QUESTIONS & RESPONSES #02

RFQ TITLE 071645 | FABULICH CENTER BUILDING ENVELOPE RESTORATION

7 STOREFRONT SILL AT PLASTER

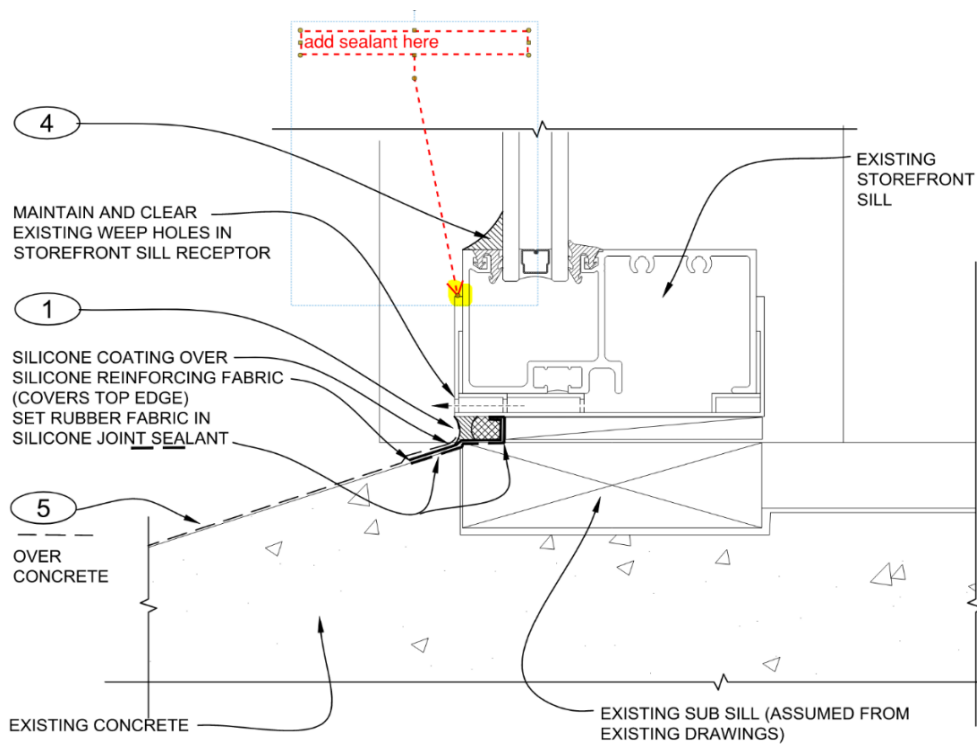
The detail of the fillet joint where the sill/header meets the window system is misleading. One detail 7/W3.01 shows it very simply as a fillet, probably standard. Whereas 3/W3.02 indicates it should be installed per 9A/W3.01 which is like a massive cove joint more in line with a wet seal application.	“Bond break tape is not needed at the small sealant fillet as noted on repair keynote 1, delete this scope. Add the fillet sealant/band aid over receiver” scope to detail 10 on W3.01 to match detail 7 on sheet W3.01.” The small fillet sealant/ band aid is not need at detail 3 because it has overhead protection. See diagram on page 2.	W3.01
The fillet joint where the sill/header can meets the window system is only shown as being addressed where there is plaster below at the sill location (Detail 7). It is not shown being addressed at the Head (Detail 3) or Sill at concrete base (Detail 10). Since it's a small item I'd prefer to get everyone bidding it the same way.	“Bond break tape is not needed at the small sealant fillet as noted on repair keynote 1, delete this scope. Add the fillet sealant/band aid over receiver” scope to detail 10 on W3.01 to match detail 7 on sheet W3.01.” The small fillet sealant/ band aid is not need at detail 3 because it has overhead protection. See diagram on page 2.	W3.01
